Department of Transportation
Michael J. Penrose, Director

County of Sacramento

Thank you for the opportunity to comment on the proposed code changes intended for inclusion in the 2013 California Building Code, Title 24, Part 2. The Sacramento County Department of Transportation (Sac DOT) has concerns related to the impacts on public rights of way, and safety created by certain proposed changes in "Section 11B-406 Curb Ramps". The specific sections that we have concerns with are noted below.

Text excerpt from the proposed 2013 CBC, **Section 11B-406.5.3 Landings**:

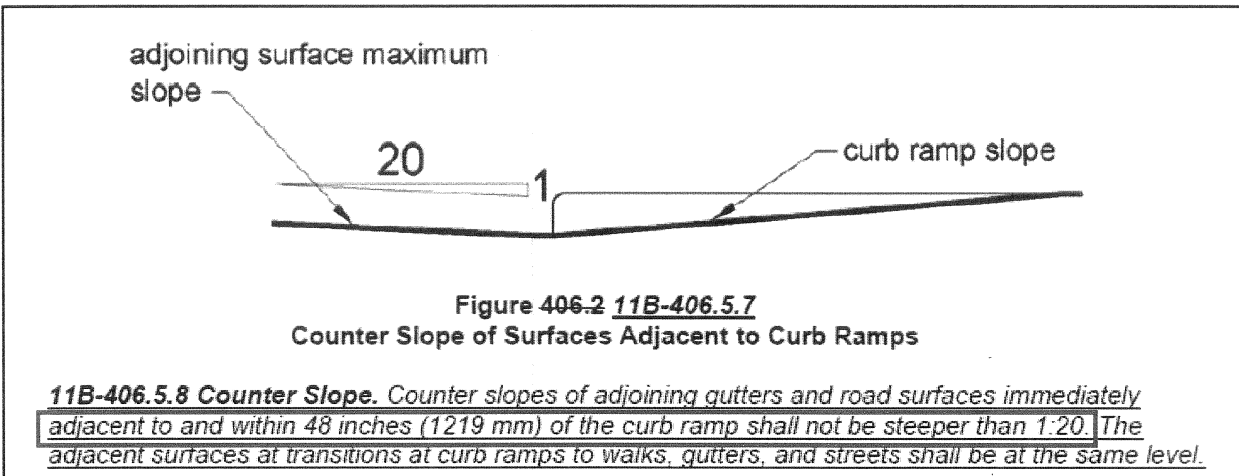
We have concerns with the slope requirement of a 48" landing at the top of a ramp to be 1:48 in all directions, this would be difficult to construct, excessively costly and unnecessary. Specifically we disapprove of the longitudinal slope requirement of 1:48, this should instead allow for the maximum 1:20 slope as allowed for accessible paths. Most of our sidewalks slopes match the grade of the adjacent street. We are currently able to provide a parallel curb ramp that goes from the sidewalk slope to a maximum slope of 1:12 for a parallel ramp. The requirement of a 48" top landing pad with a maximum longitudinal slope of 1:48 also creates complications with the normally constant curb height and the matching sidewalk surface. This 1:48 slope criteria will also create a costly transition compliance issue when an existing driveway is adjacent to, or near the top landing of a curb ramp. We recommend maintaining the 1:48 slope criteria for the cross slope (perpendicular to the curb) of the landing area and maintaining the currently allowed 1:20 for the longitudinal slope of the accessible path.
